FIELD CHANGE ORDER

Issued by: PMS DMC HamburgReference No.: FC074200007Released by: Karl-H. HamburgsignedDate: September 2, 2002

Transport wheel problems with generator cabinet 40E.

Illustration 1

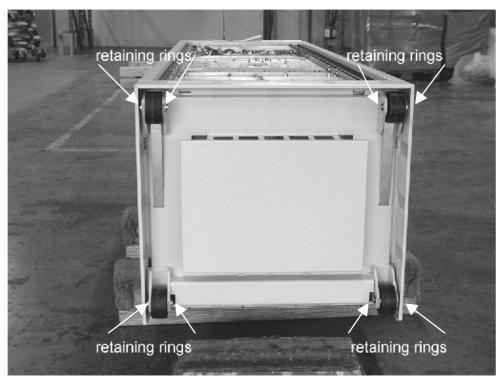
Check of all four transport wheels (illustration 1).

The four transport wheels are secured with retaining rings on the axles.

The retaining rings are located on the left-hand and right-hand side of each axle (8 pieces).

Illustration 2

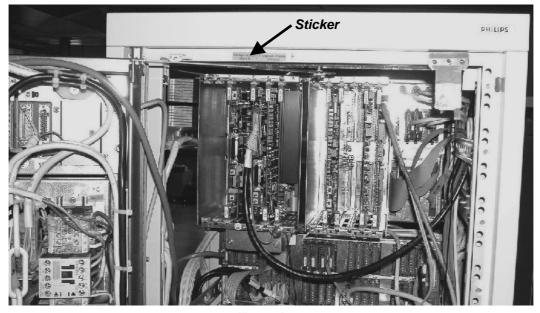
• Check for sticker 'Transport Wheels Checked' at the upper left corner of the cabinet (illustration 2).

• Stick the sticker at the upper left corner of the cabinet (illustration 2 on page 3).

Illustration 6

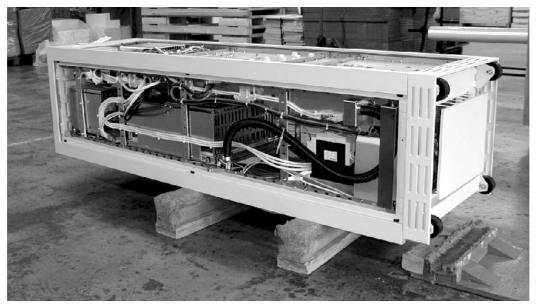
• Tilt the cabinet through 90° and place it upon suitable wooden bars (illustration 6).

- Check the washers are still in place.
- Use suitable pliers to insert the retaining rings properly in their groves.
- Continue at step 'Re-attach the HV tank......', point 3 on next page.
- 2.) The retaining rings are missing completely (Illustration 7).
